M.S. ASUKA MARU.

ALTERATION PLAN OF PUMPING ARRANGI.

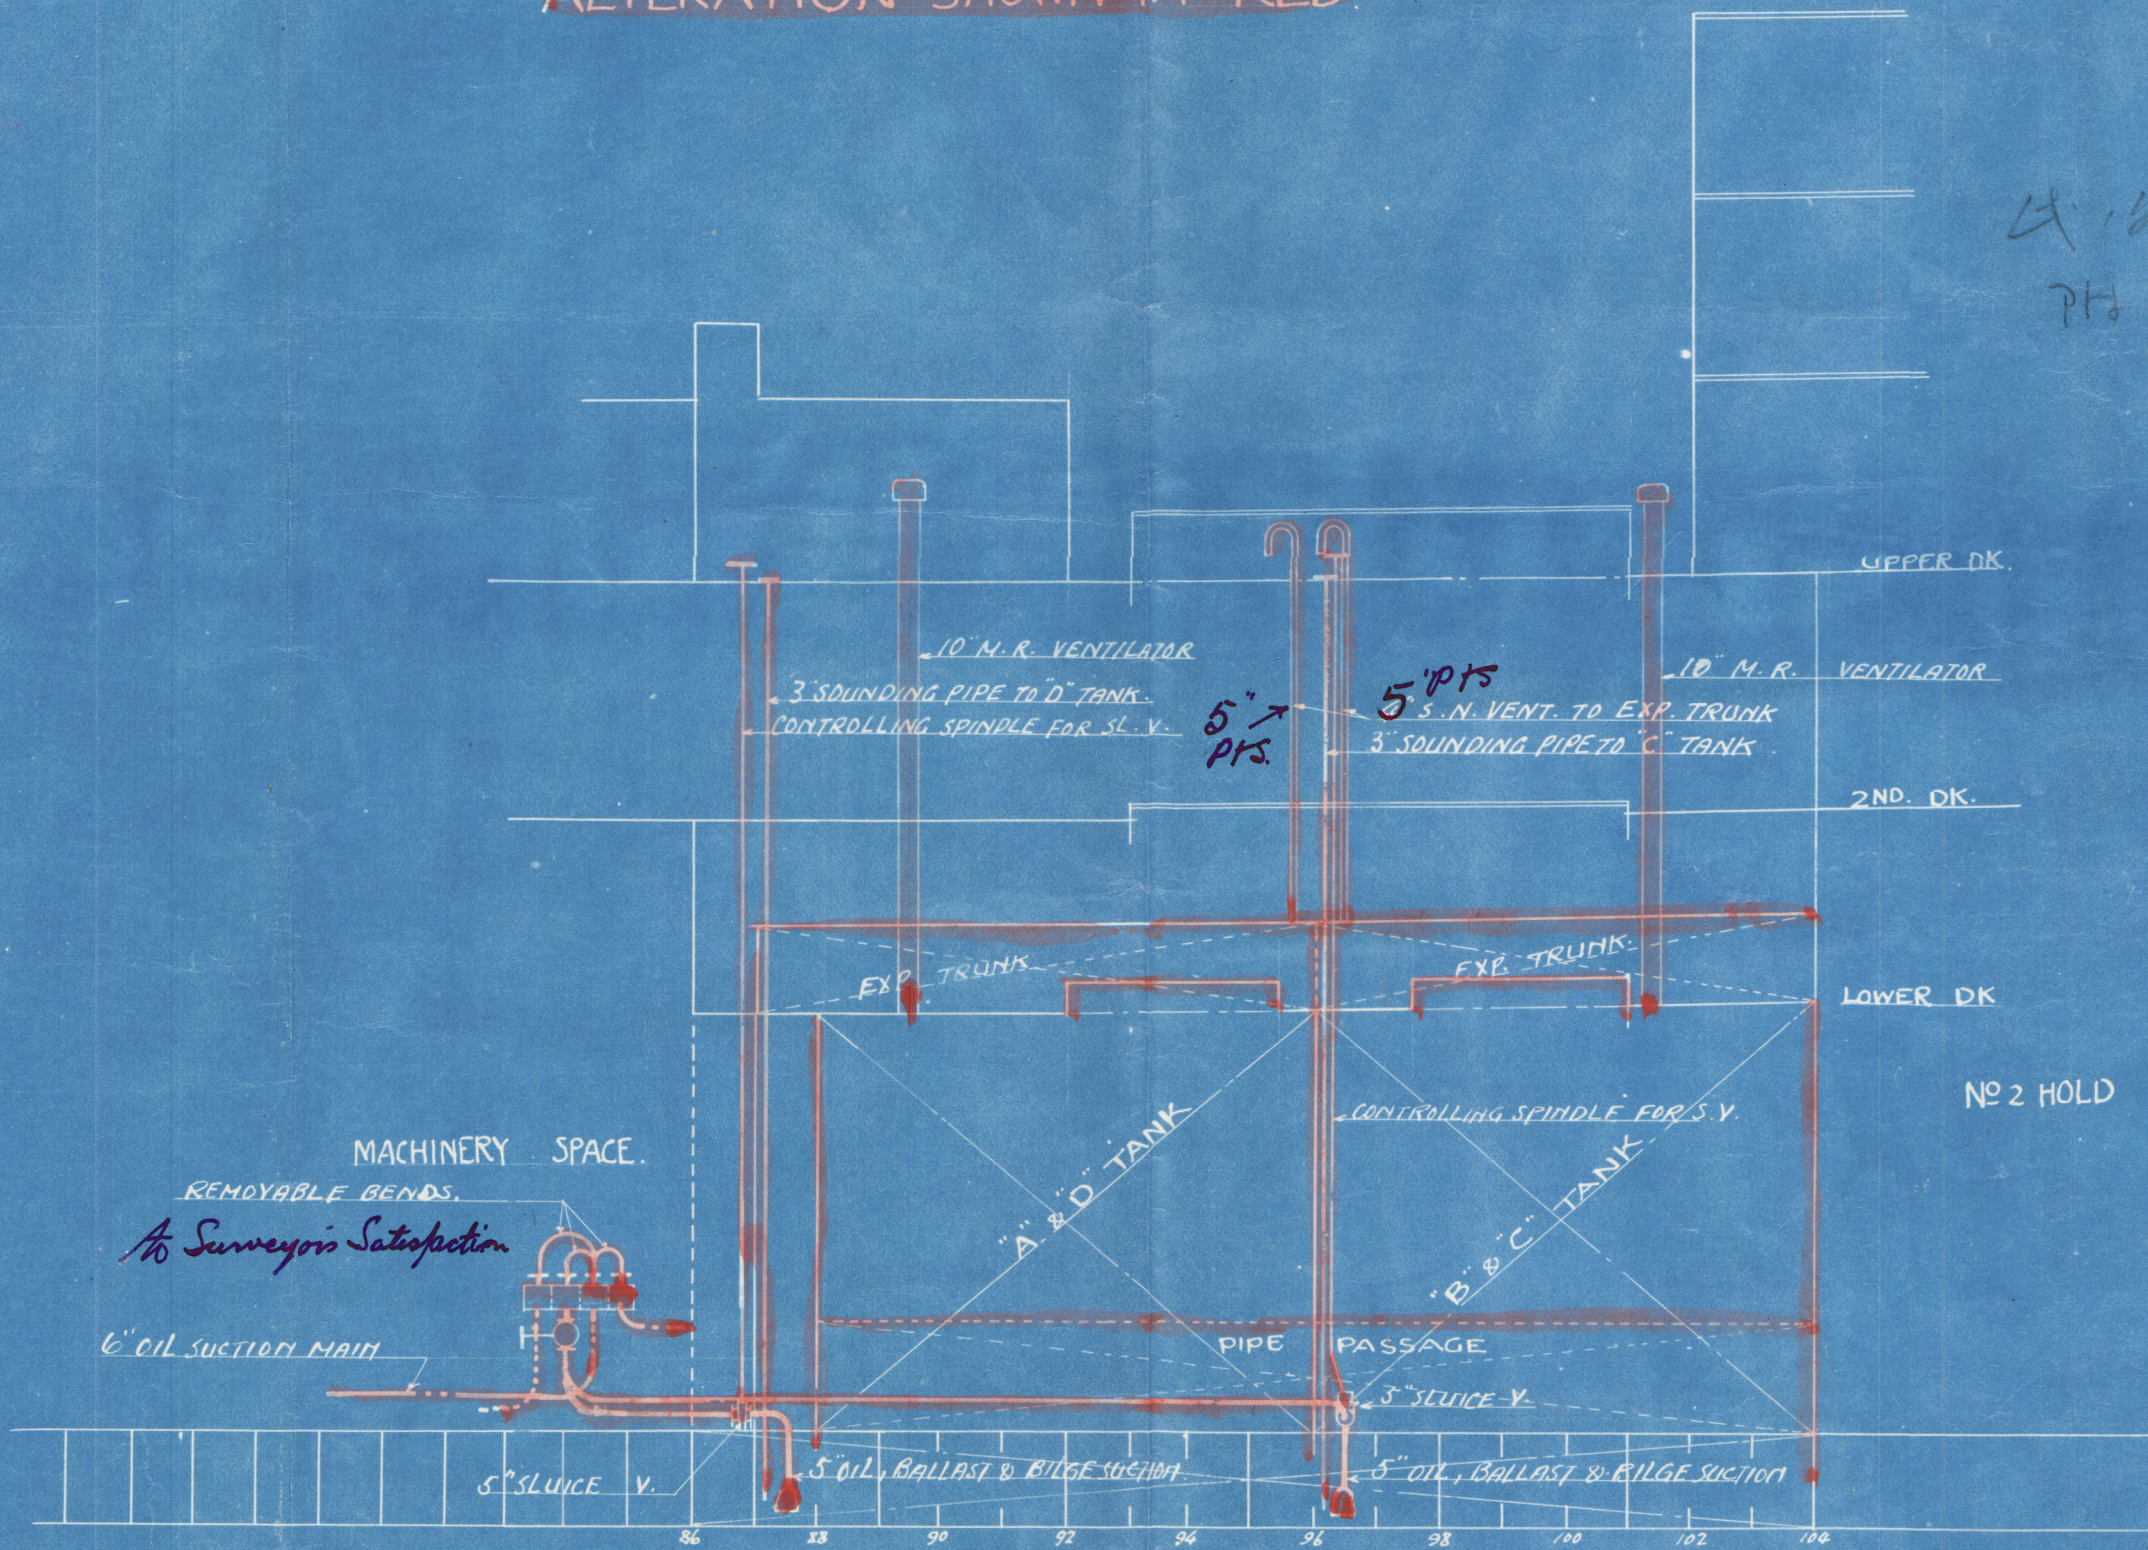
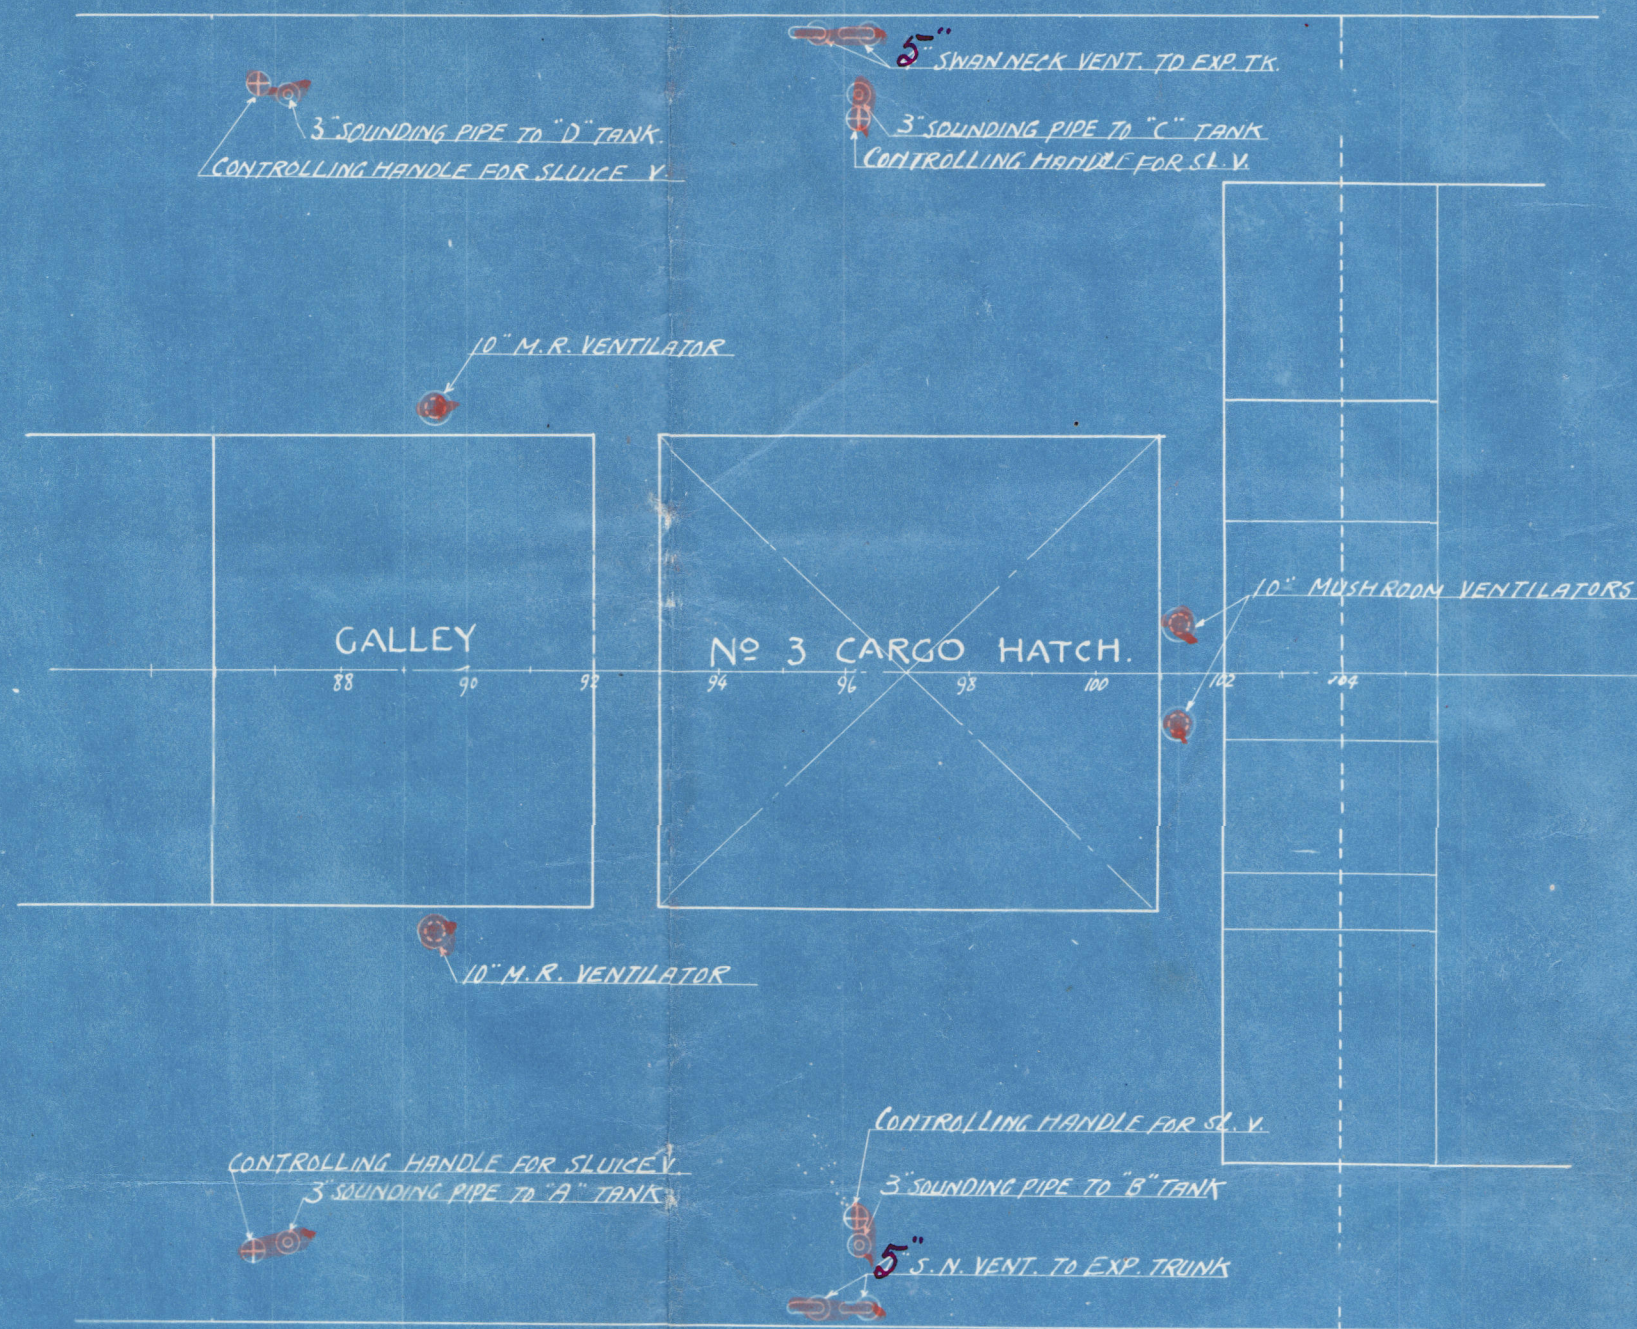
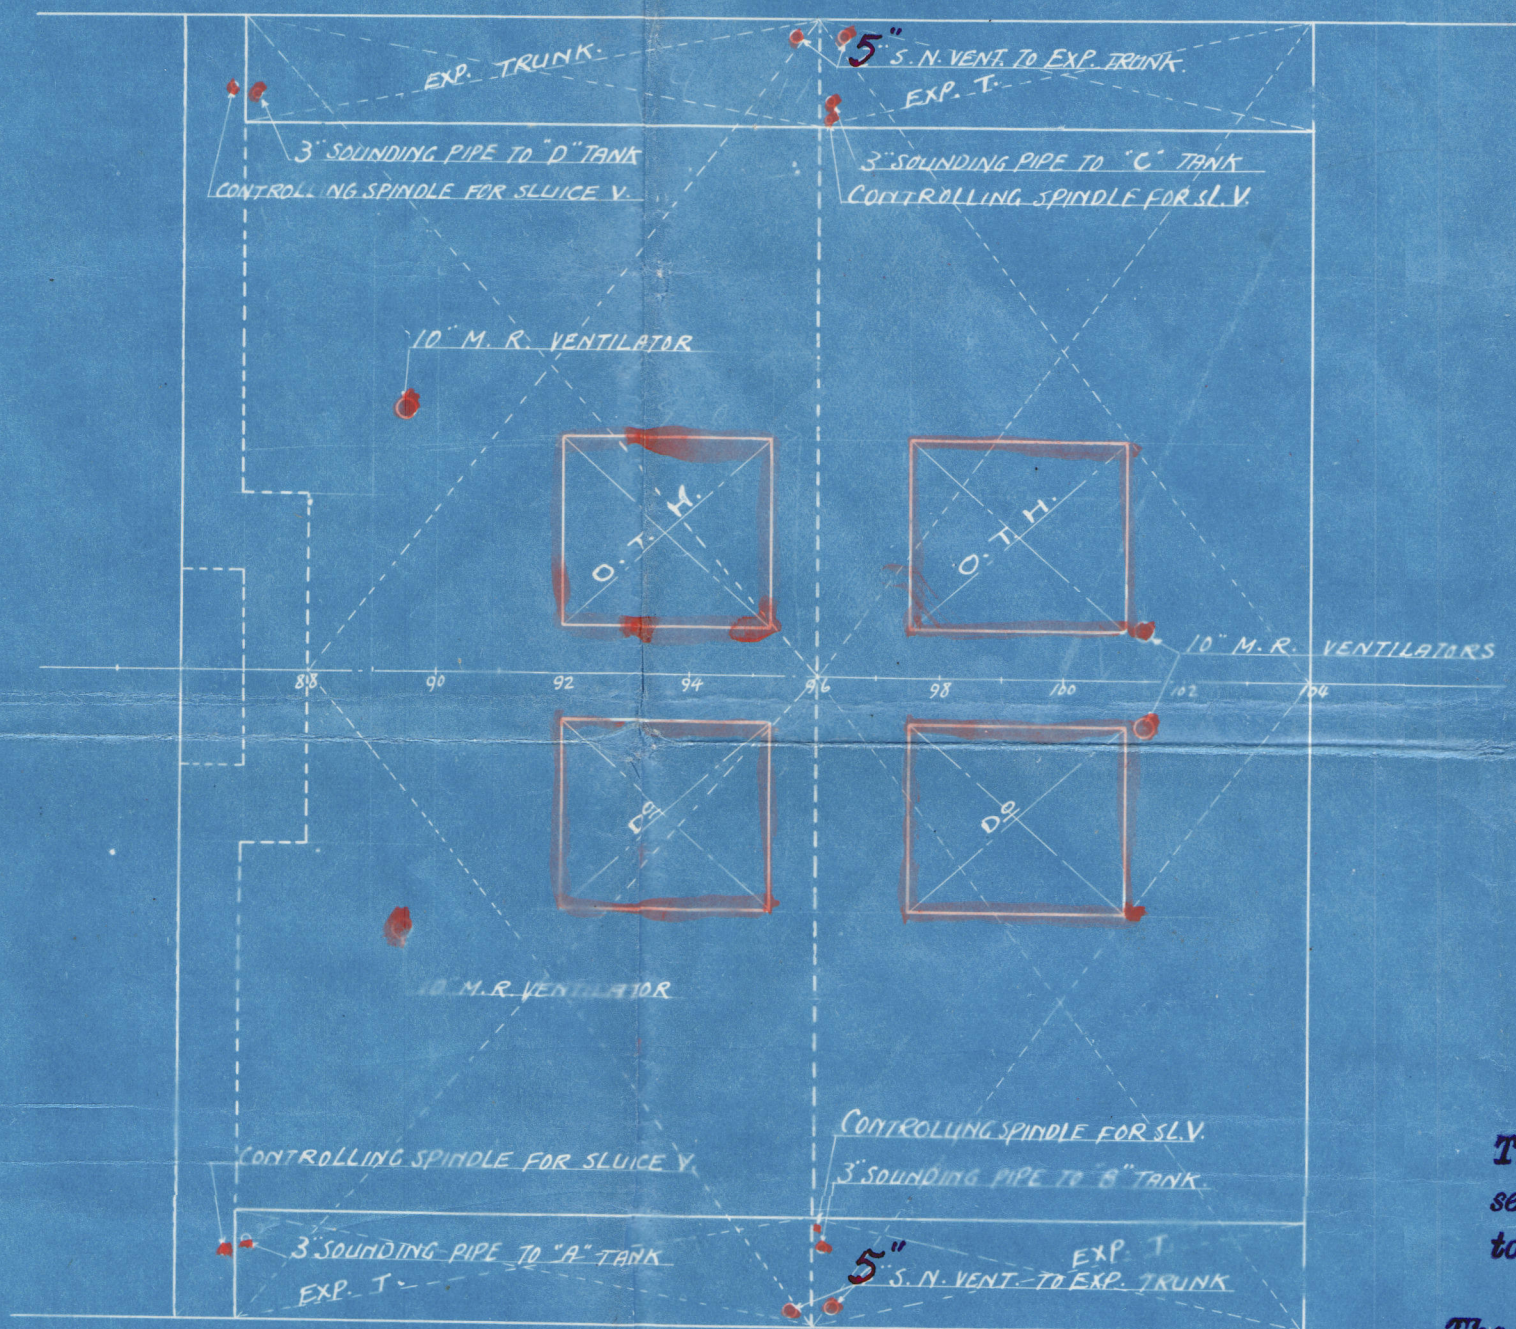
The remaining requirements of section 34 of the rules to be complied with.

The flash point of the oil fuel to be above 150° F. and those remaining requirements of section 35 of the rules which apply to be complied with.
